# Bobcat/Bunton Information Bulletin

**Bulletin No: C-012-04**

## **Kawasaki FH601V/FH680V/FH721V Oil Leak**

### #1 Cylinder Head Oil Leak (FH 601D, 641D, 680D, 721D) (FH 601V, 641V, 680V, 721V)

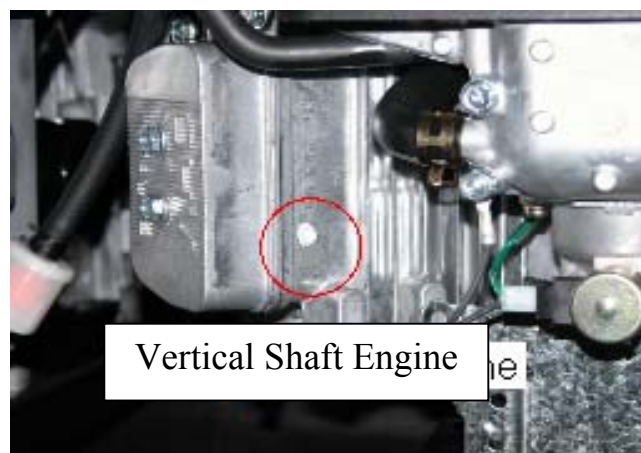
Oil leaks from the #1 cylinder head (Right side if viewing the engine from the back) near the oil return hole. This was caused by a defect in the casting die.

Kawasaki corrected the casting die and reworked engines in inventory. Kawasaki has also initiated a Factory Directed Modification (FDM) campaign to repair eligible field units. Each machine manufacture will notify end users of this campaign and direct them to an authorized dealer for repair.

### Repair Eligible Cylinder heads:

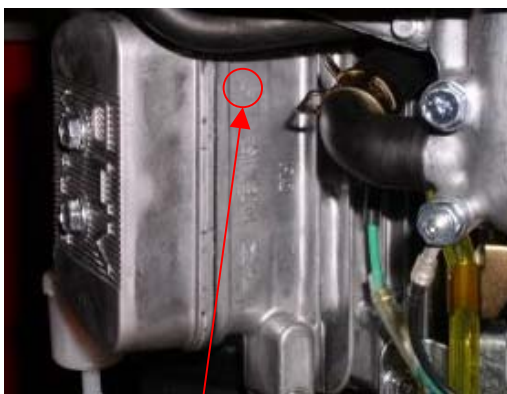
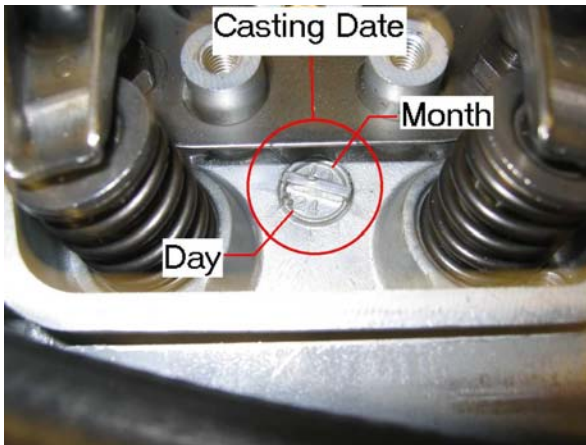
Engines in listed serial number range may have heads produced with defective casting die. (Cylinder heads produced between 7/31 and 10/21 with "K-3" die are suspect.)

Engines having a white dot painted on the cylinder head have been reworked before shipping to dealers and are not eligible for this repair even if they are in the above range.

- Determine if engine is within the suspect serial number range.
  - Check if cylinder head is a "**K-3**" casting die. (No problem on K-1, K-2)
  - Check if there is a white dot painted on the cylinder head. If there is no dot, Kawasaki has not reworked the engine.
  - Remove #1 rocker arm cover to inspect casting date.
- If the casting date is in the suspect range (7/31 to 10/21), replace cylinder heads.
